**HISTORIC LANDMARK COMMISSION  
MAY 21, 2012  
NATIONAL REGISTER HISTORIC DISTRICT  
NRD-2012-0046  
Willow-Spence  
1002 Willow Street**

Construct a new approximately 1,500 sq. ft., detached, two-story, 3 car garage with office.

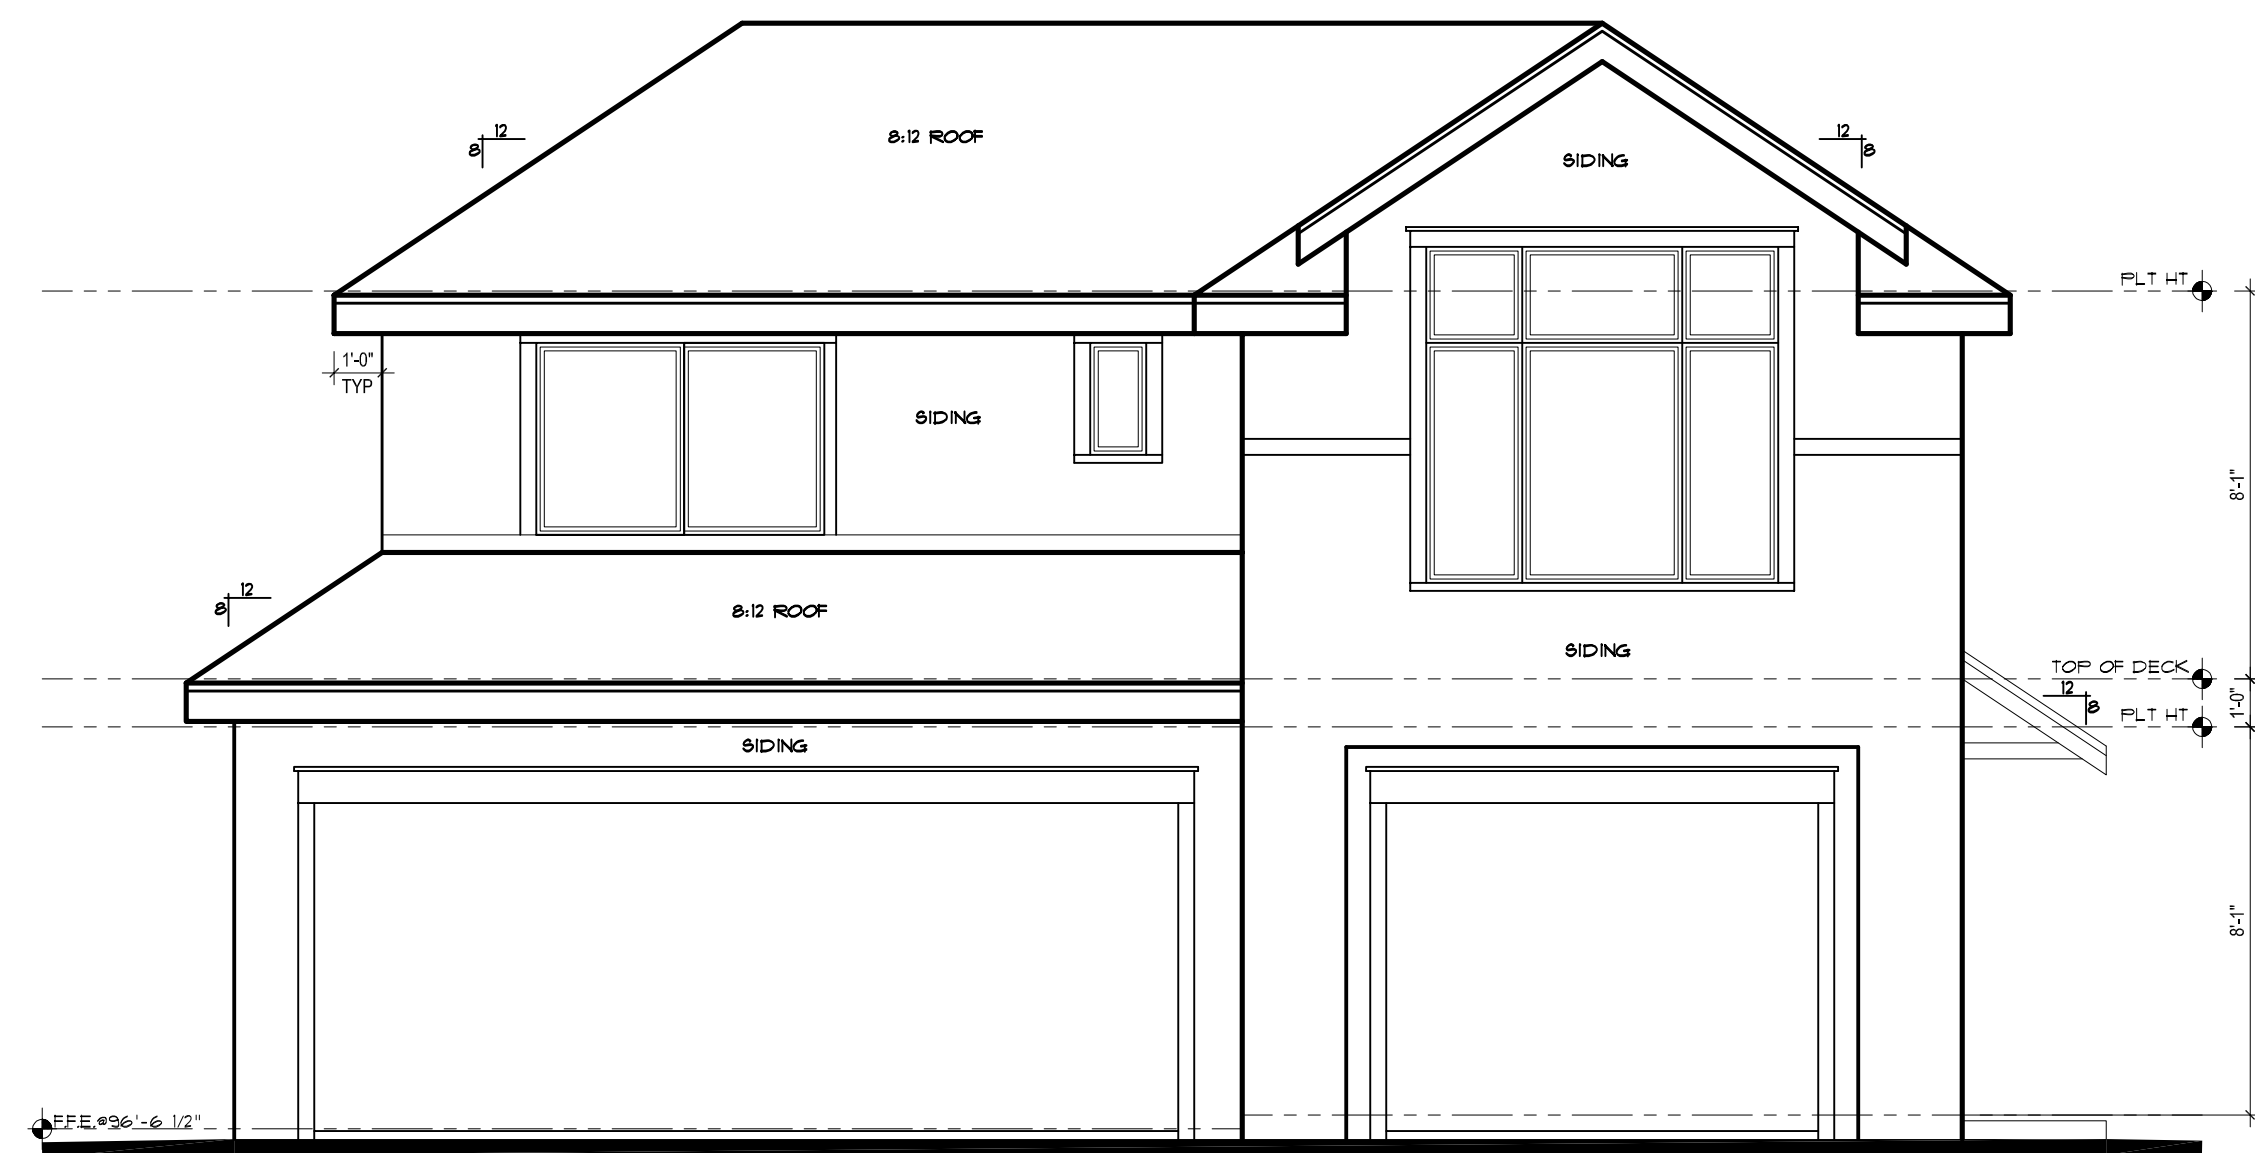
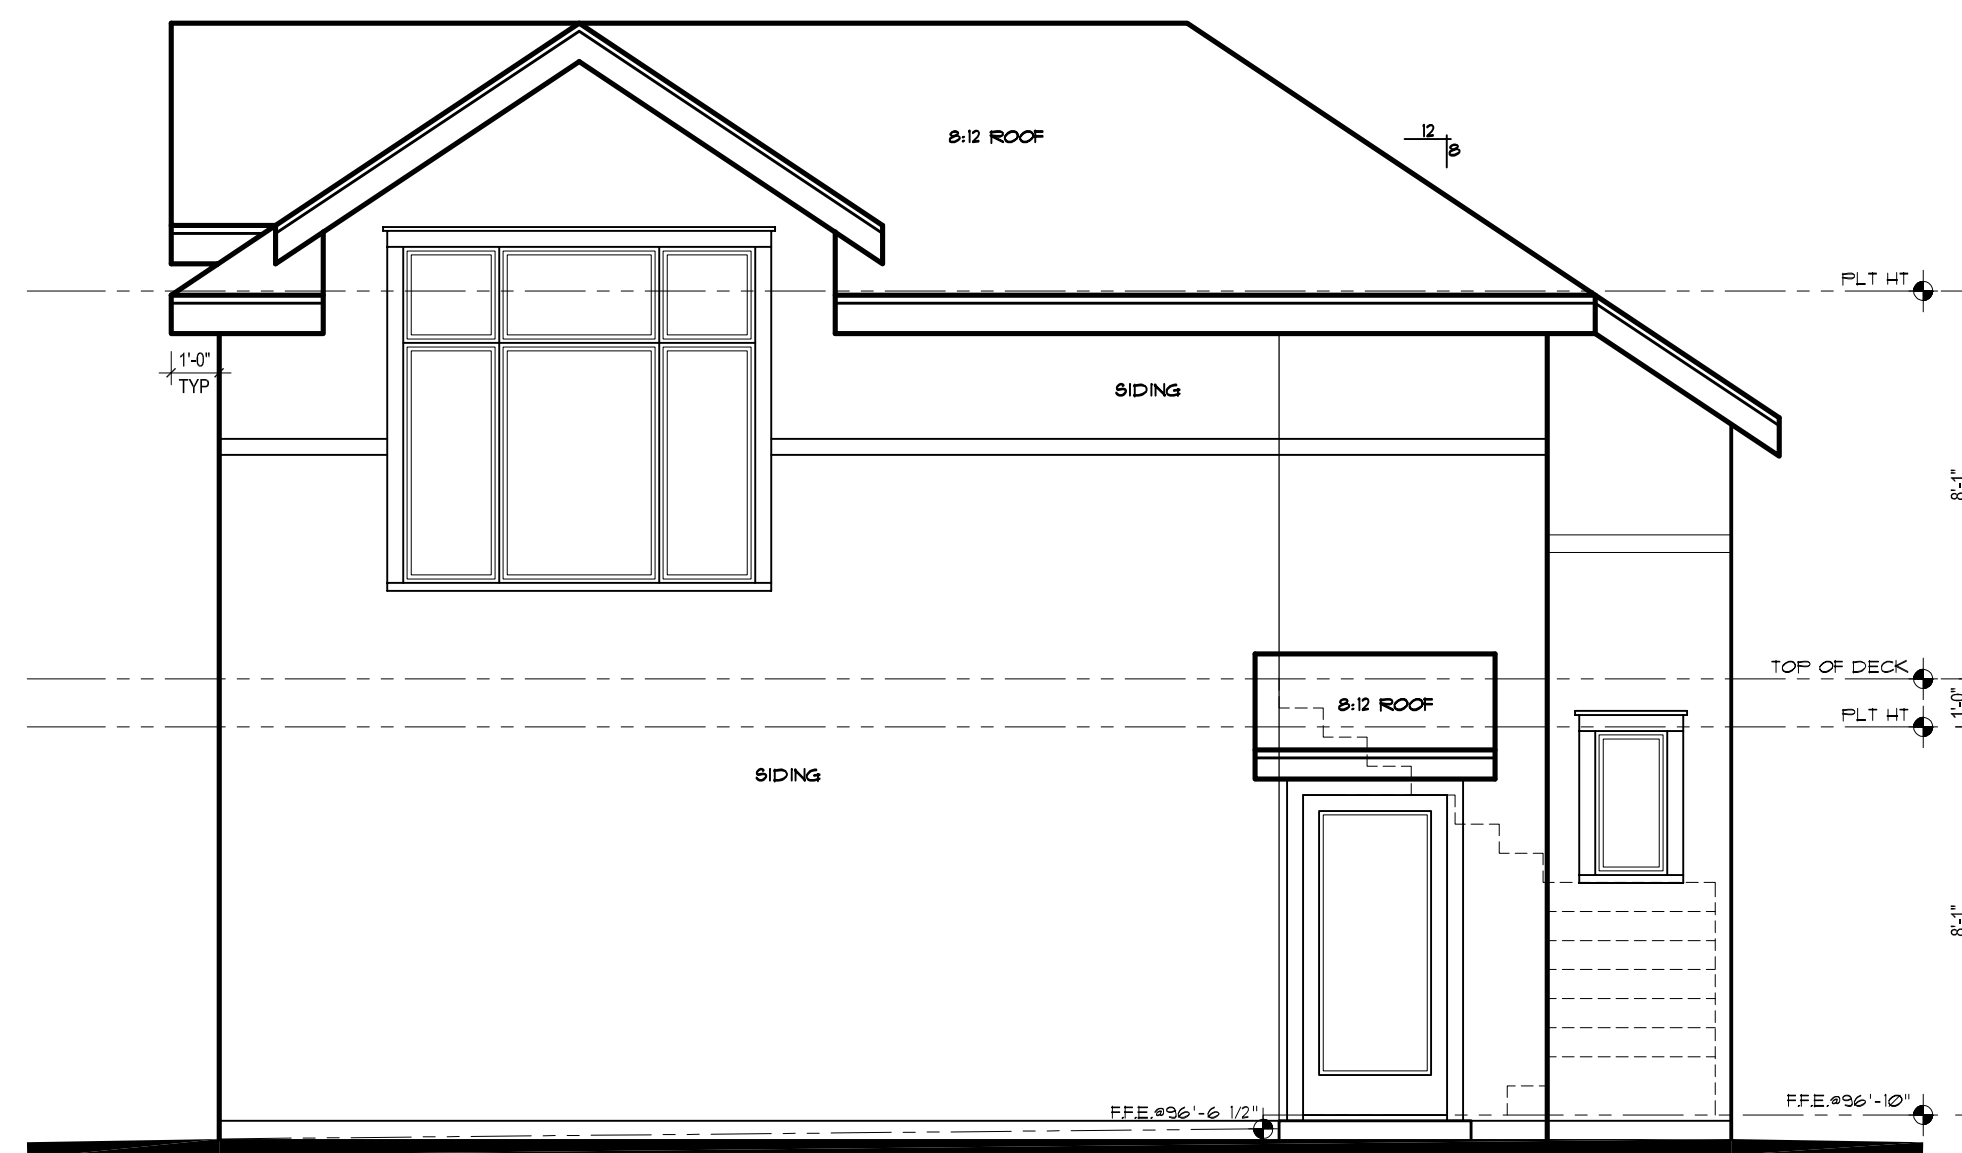
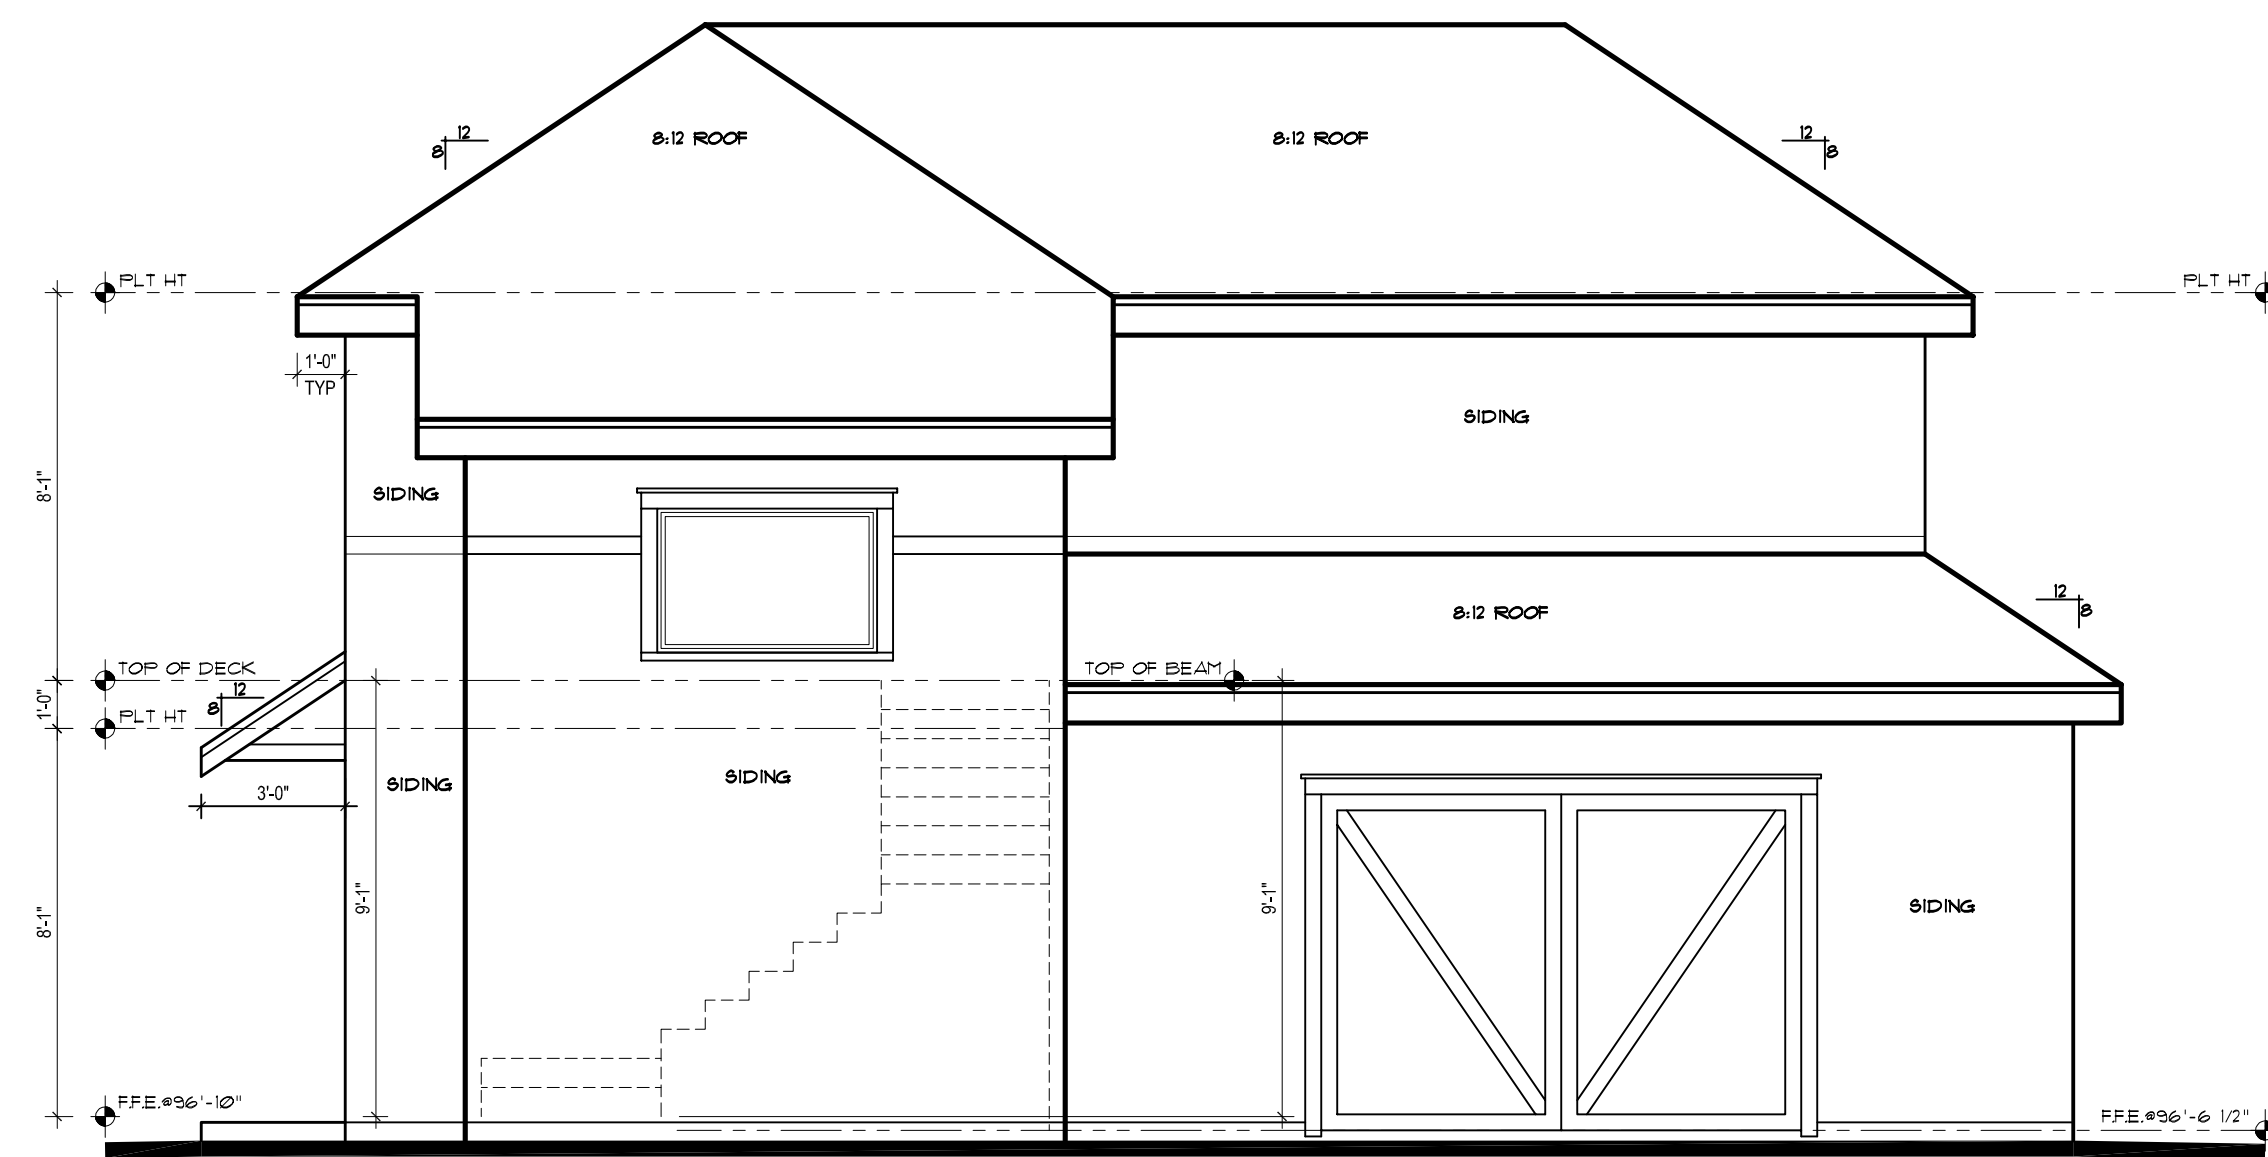
The garage will have a multiple-pitch, hipped roof, with narrow eaves. Wall and roof materials will be 4-5" wide, horizontal Hardiplank siding, and asphalt shingles to match the existing house. The garage doors will be panelized metal.

The proposed new structure is to the rear of the property and its scale and materials are compatible with the National Register District.

Release the permit per the proposed design.
